MEMORANDUM

From:	Tina Cuss Ecology Officer		
Service	WBC Ecology	App No:	250996
Address:	Broom House, Maidenhead Road, Binfield, Wokingham, RG40 5RH.		
Proposal:	Application for submission of details to comply with the following condition of planning consent 230576 dated 06.09.2023. Condition 8 relates to external lighting.		
Type of Development:			
Site Visit Made:	No

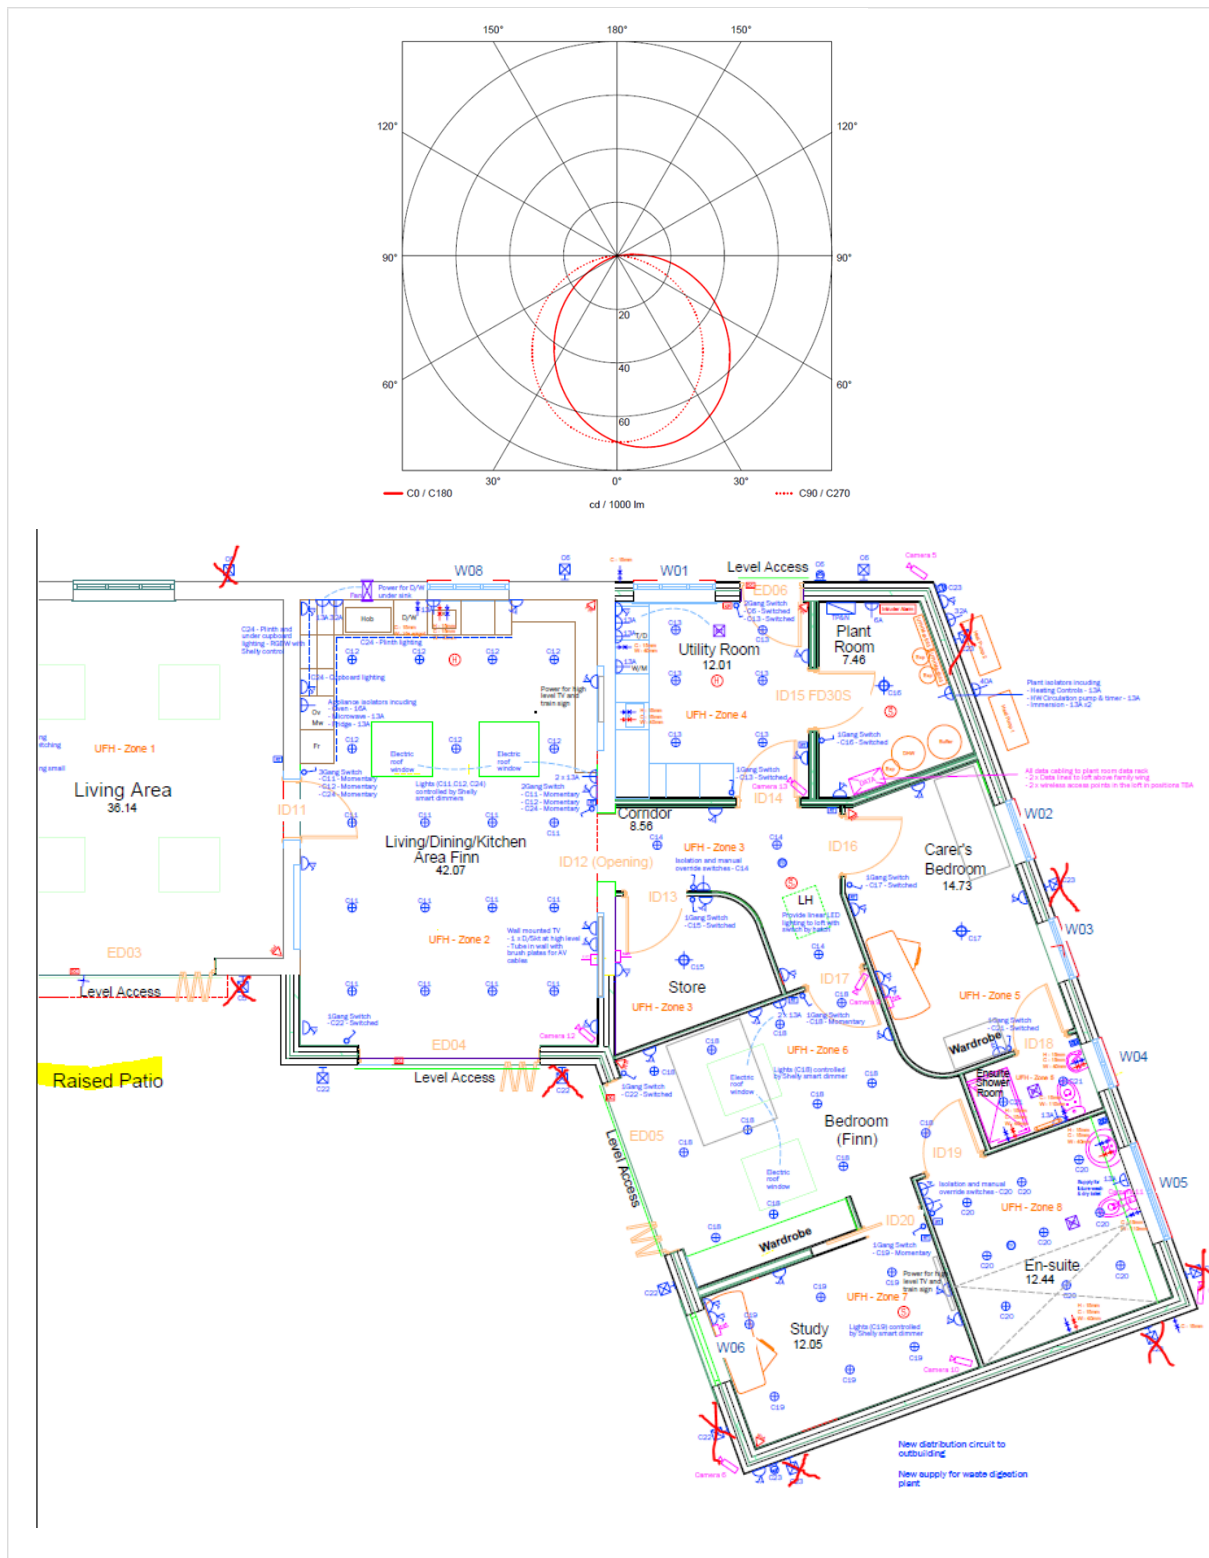
I am not satisfied that the 320 lumen OD-YOK high output has been justified. The luminaires are brighter than is necessary and do not adequately conform with recommendations of the Ecologist for 3 lux or lower. There are significantly more wall and ceiling lights than are necessary including lighting in pairs sited close together and luminaries in corners and the end of the buildings. The lighting scheme fails to protect dark corridors around the bat roosts and the southern boundary vegetation.

I request that luminaries with narrower light spill are considered, and the units marked in red which are unnecessary and that will cause excessive light spill and contrast are omitted.

Awaiting amended details on controls and circuits, lighting contours and measures to control lighting and removal of additional luminaries on the southern, northern and eastern elevations which are not needed for health and safety and lighting of the patio.
